Justification for Class II permissive change – AT&T1430

FCC ID: EW780-5125-H01 & EW780-5125-B01

The description Difference Between AT&T1430 and AT&T1430MK2

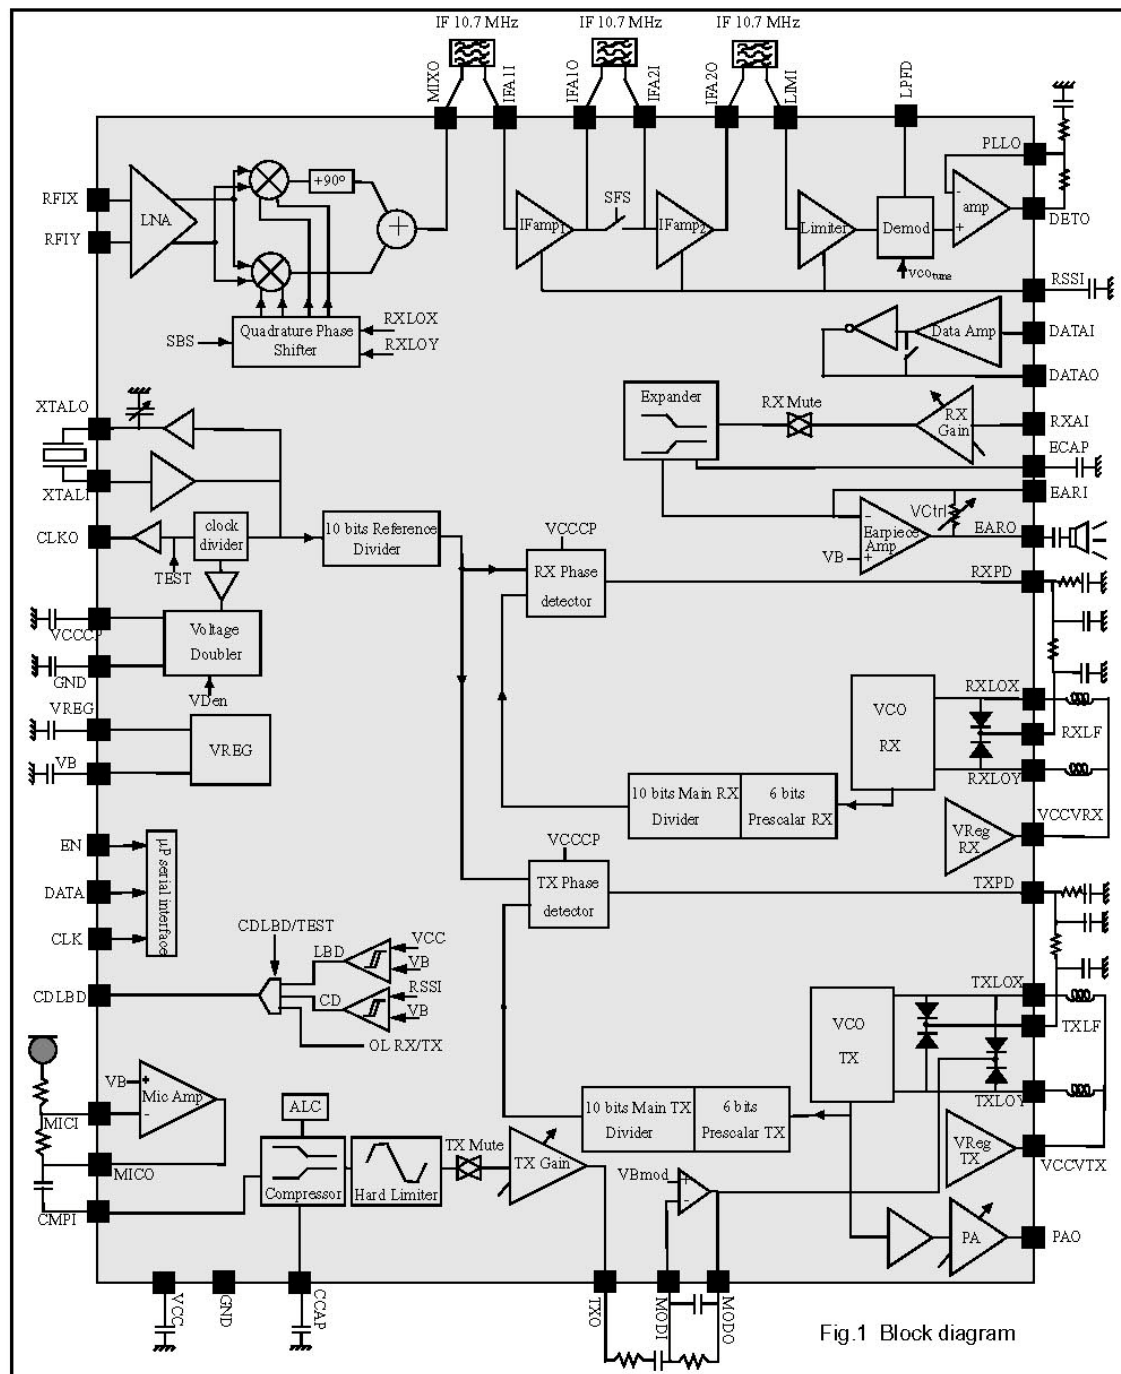
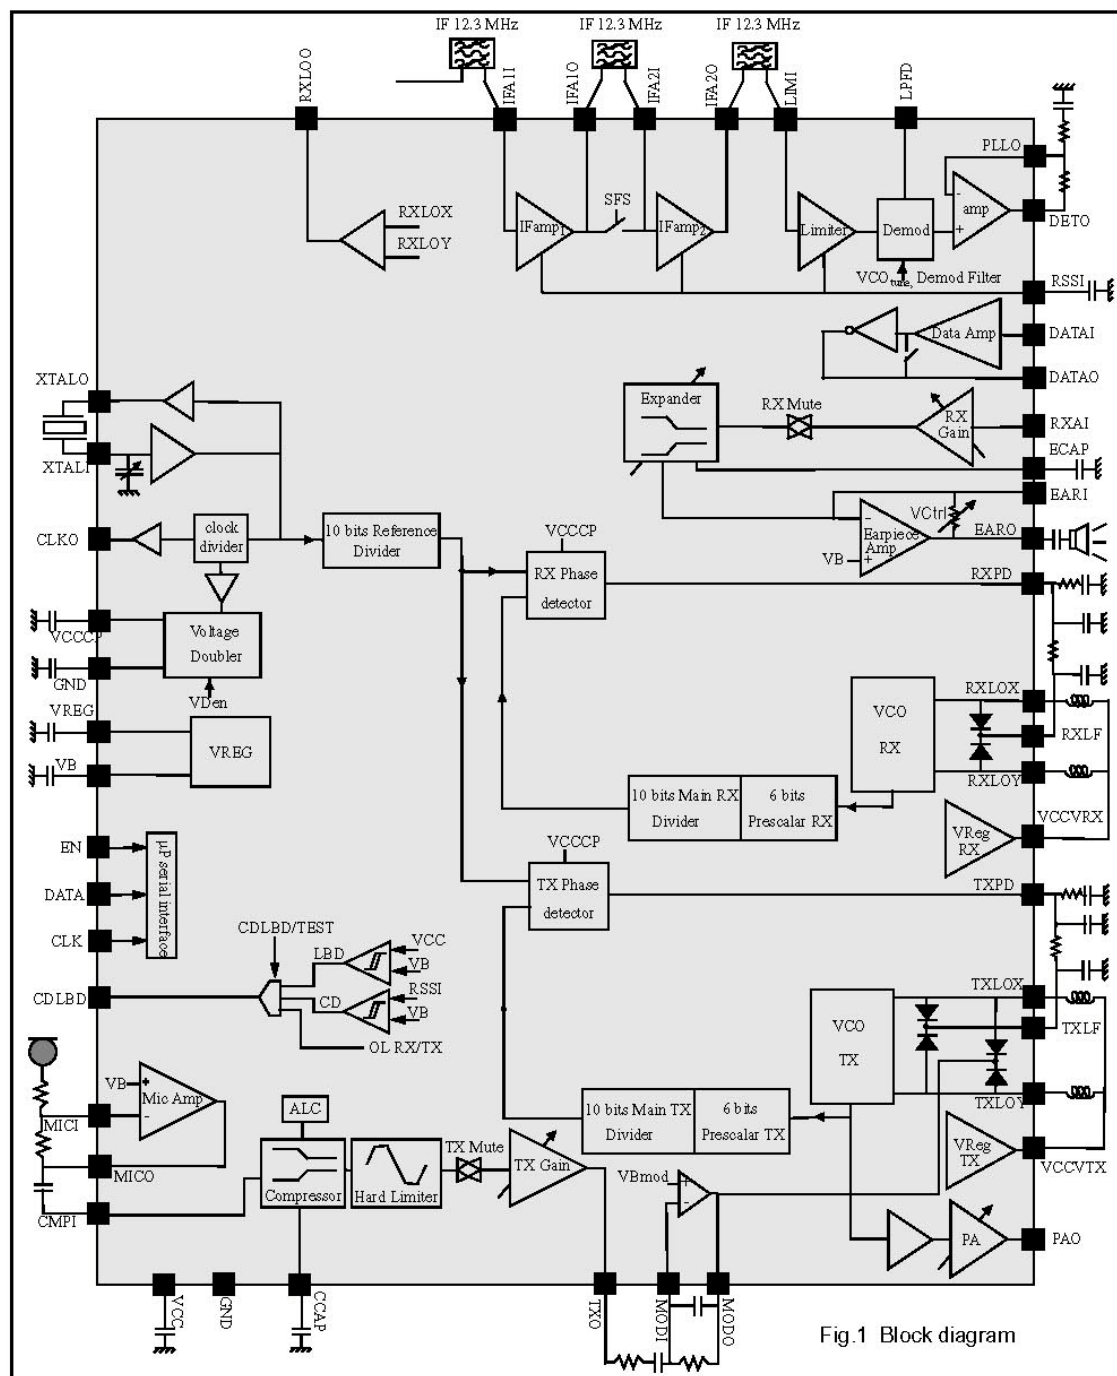
- a) Internal block diagrams of U3515 (old) & U3517B (new) – attached.
U3515 is a 900MHz RF IC, so in previous design the Rx PLL, VCO, LNA, Mixer could not be used on Handset receive (2.4GHz).
In the new U3517B, the Rx PLL, VCO are re-designed for 2.4GHz, so previous external discrete Rx PLL, VCO are no longer required. The unused LNA, Mixer inside U3515 were not implemented in the new RF IC U3517B as shown in the block diagram.
- b) The above was also mentioned in the Theory of Operation filed in FCC during previous new approval (10/1/01) on EW780-5125-H01 & EW780-5125-B01. The full doc. can be available for comparison when request.

- 1) Tx – using discrete components to replace LC filter is not considered as major change.
- 2) Rx – the integration of Rx PLL & VCO to RF IC U3517B is a planned migration that keeps all RF stages & frequencies remain the same. This will not affect the intended radiation & the unintended radiation was tested & verified to be within FCC limits.

AT&T1430	AT&T1430MK2
RF section		Base on MK1,details of modification: 1. Integrated the external RX PLL and RX VCO into RF IC U3517B. 2. Canceled 2.8V Regulator. 3. Used U3517B to replace U3515. 4. Discrete components BPF in stead of 915MHz LC filter.
Audio circuit		1. Cancel 5V LCD, use 6V LCD. 2. Added a control circuit for RF 2.8V supply. (Q6,Q7)
MCU circuit	same	same
Power management		1. New DC voltage arrangement---use 3.0V regulator to replace 2.5V.
